Proposal for a new 07 series of amendments to Regulation No. 48 (Installation of lighting and light-signalling devices)

The text reproduced below was jointly prepared by the experts from The Netherlands and Italy to serve as a discussion document for the possible introduction of new requirements for headlamp levelling, in particular regarding the vertical inclination in relation to the dipped-beam headlamp mounting height.

The above limits ~~and the initial aiming values~~ are summarized in the diagram below.

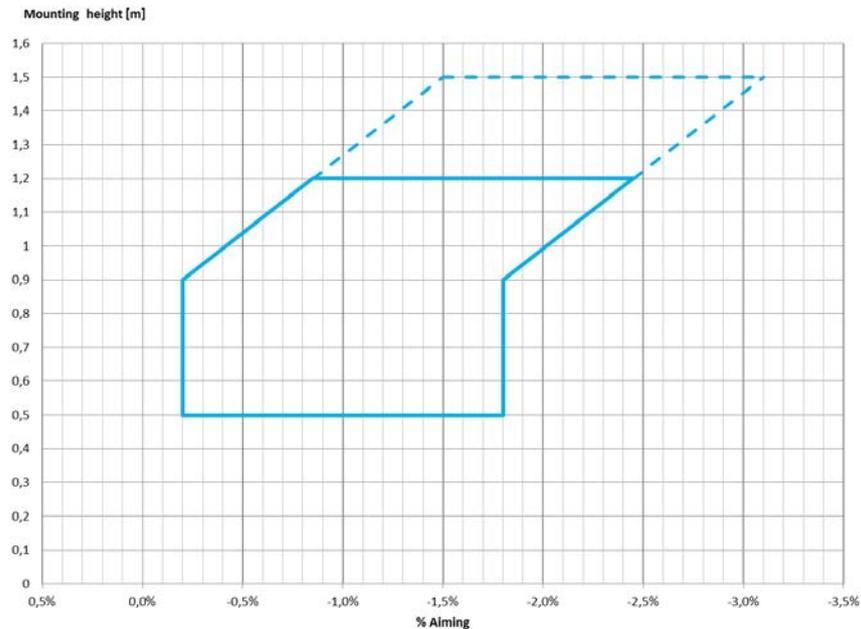
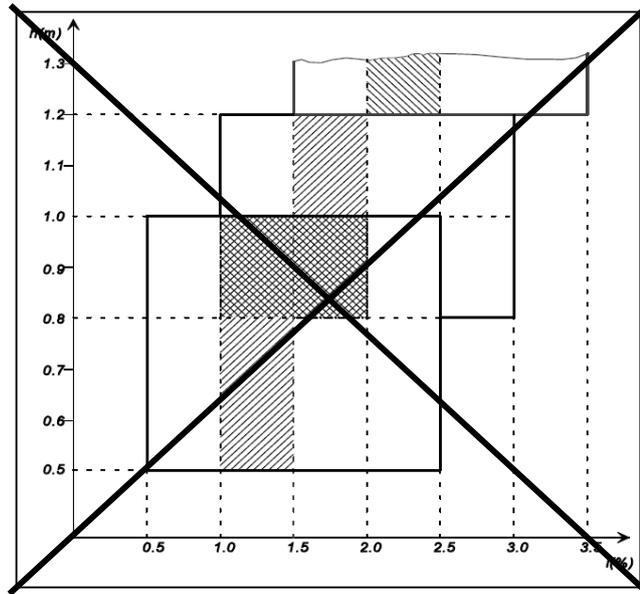
6.2.6.1.2. Depending on the mounting height in metres (h) of the lower edge of the apparent surface in the direction of the reference axis of the dipped-beam headlamp, measured on the unladen vehicles, the vertical inclination of the cut-off of the dipped beam, **starting from the initial inclination value set by the vehicle manufacturer as prescribed in paragraph 6.2.6.1.1. above,** shall ~~under all the static conditions of Annex 5,~~ remain between the following limits, **under all the stating loading conditions of Annex 5:**

for 0.5 m < h < 0.9 m, between:

-0.2 % and -1.8 %;

for 0.9 m < h < 1.2 m, between:

the minimum vertical inclination limit increasing linearly, in relation to the dipped-beam headlamp mounting height,

from - 0.2 % to - 0.8[5] %

the maximum vertical inclination limit increasing linearly, in relation to the dipped-beam headlamp mounting height,

from - 1.8 % to - 2.4[5] %;

for 1.2 m < h < 1.5 m, between:

the minimum vertical inclination limit increasing linearly, in relation to the dipped-beam headlamp mounting height, from

- 0.8[5] % to - 1.5 %

the maximum vertical inclination limit increasing linearly, in relation to the dipped-beam headlamp mounting height, from

- 2.4[5] % to - 3.1 %.]

- 4.2. This paragraph is modified to update the reference to the new series of amendment 07.
- 6.2.6.1.1. Second indent is modified to better prescribe how to define the initial aiming value. Last indent is added to clarify how to correctly indicate the initial aiming value in case where it is different for different variants/versions of the same vehicle type. This paragraph is in square brackets since it was not agreed during the VGL works.
- 6.2.6.1.2. The range of vertical orientation has been modified based on the IWG VGL decisions. IWG VGL decided to present a proposal in which this range is from 0% to -1.6 %; it was also agreed

that, if requested by GRE Experts, the 0 % limit will be moved to the -0.2 % limit maintaining the 1.6 % range (i.e. shifting in parallel the upper limit to -1.8 %). UK and PL requested OICA to provide better justifications for the need to have a range at least 1.6 % wide.

At GRE 78 some Experts requested to shift the 0 % limit to -0.2 % and no Expert opposed the parallel shifting of the -1.6 % limit to -1.8 % limit. UK and PL reiterated their request for better justification for the need to have a range at least 1.6 % wide.

As far as the range of vertical orientation for N3G category vehicles having headlamps installed at more than 1.2 m from the ground is concerned, IWG VGL did not take any decision, even if the idea to follow the same parameters used for the other vehicles categories was discussed. The proposed values are then put in square brackets; in any case they provide an improvement, from illumination distance point of view, in respect to the present requirements.

Finally, among the proposed orientation limit values, two of them should have, from calculation, 2 digits after the comma, while only 1 digit after the comma is indicated in the present R48 text. Consequently the second digit is always indicated in square brackets, to decide whether to maintain it or round the first digit to the nearest value.

Model A

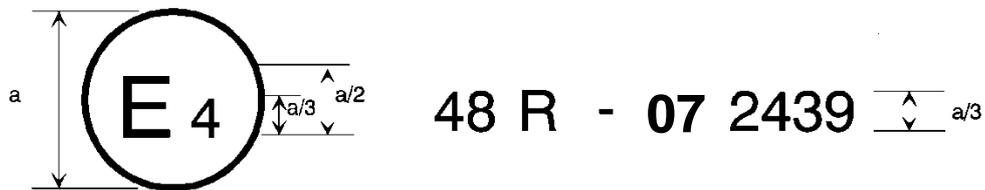
The above approval mark affixed to a vehicle shows that the vehicle type concerned has, with regard to the installation of lighting and light-signalling devices, been approved in the Netherlands (E 4) pursuant to Regulation No. 48 as amended by the 06 07 series of amendments. The approval number indicates that the approval was granted in accordance with the requirements of Regulation No. 48 as amended by the 06 07 series of amendments.

- Annex 2 This annex is amended to update the marking examples and related description to the introduction of the 07 series of amendments.
